From: Melissa Rassack
Sent: Monday, 5 July 2021 4:09 PM
To: Bianca Thornton
Cc: Liza Miller; William Hodgkinson
Subject: RE: Request for advice on SEARs - 1-51 Aldington Road Estate (SSD-22595032)

Response to Request for Advice on SEAR's Request: 1-51 Aldington Road Estate Warehouse and Distribution Use - SSD-22595032

**1-51 Aldington Road Estate (SSD-22595032)
Comment on the Secretary's Environmental Assessment Requirements (SEARs)**

Figure 1: Pre-Development Development Scale Flow Duration Curve (refer spreadsheet attached)

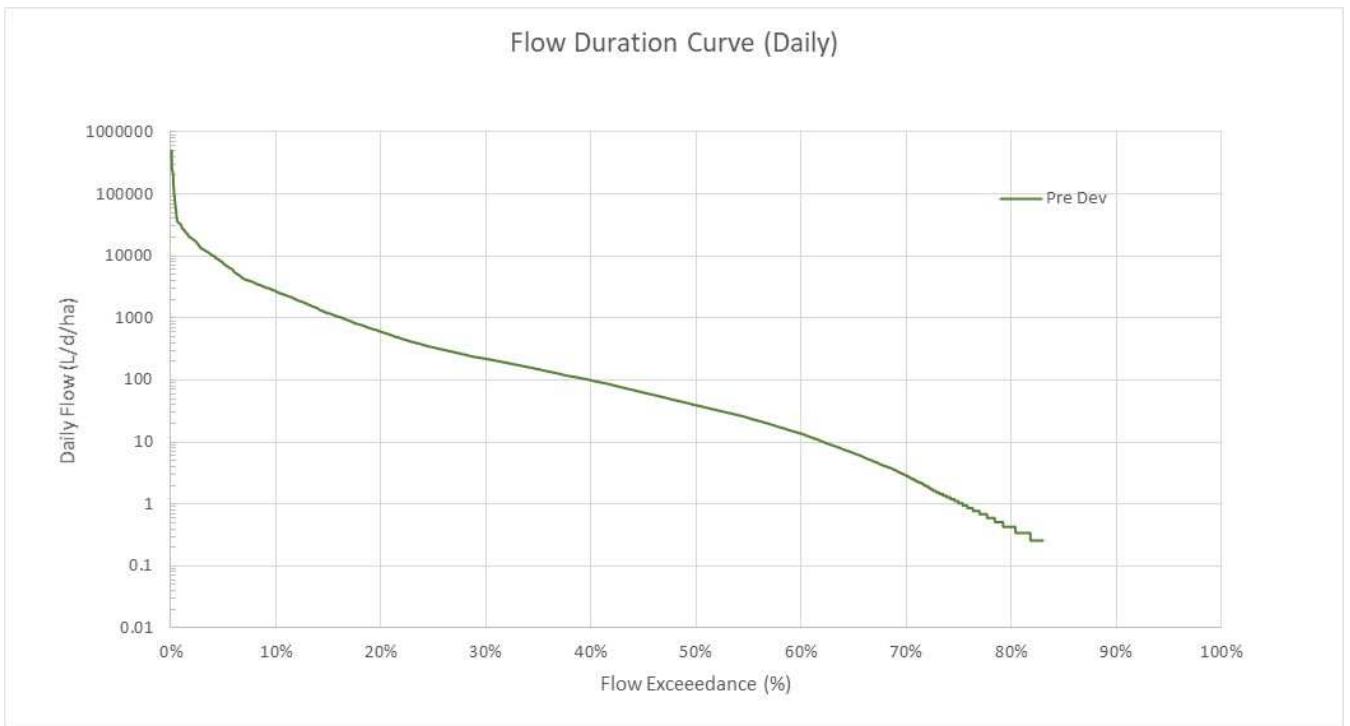
Impervious Area Parameters	
Rainfall Threshold (mm)	1.0
Pervious Area Parameters	
Soil Storage Capacity (mm)	150
Initial Storage (% of capacity)	30
Field Capacity (mm)	130
Infiltration Capacity Coefficient – a	175
Infiltration Capacity Exponent - b	2.5
Groundwater Properties	
Initial depth (mm)	10
Daily Recharge Rate (%)	25
Daily Baseflow Rate (%)	1.4
Daily Deep Seepage Rate (%)	0.0

- Pollutant export parameters must adopt those recommended in *WSUD developer handbook MUSIC modelling and design guide 2020*.
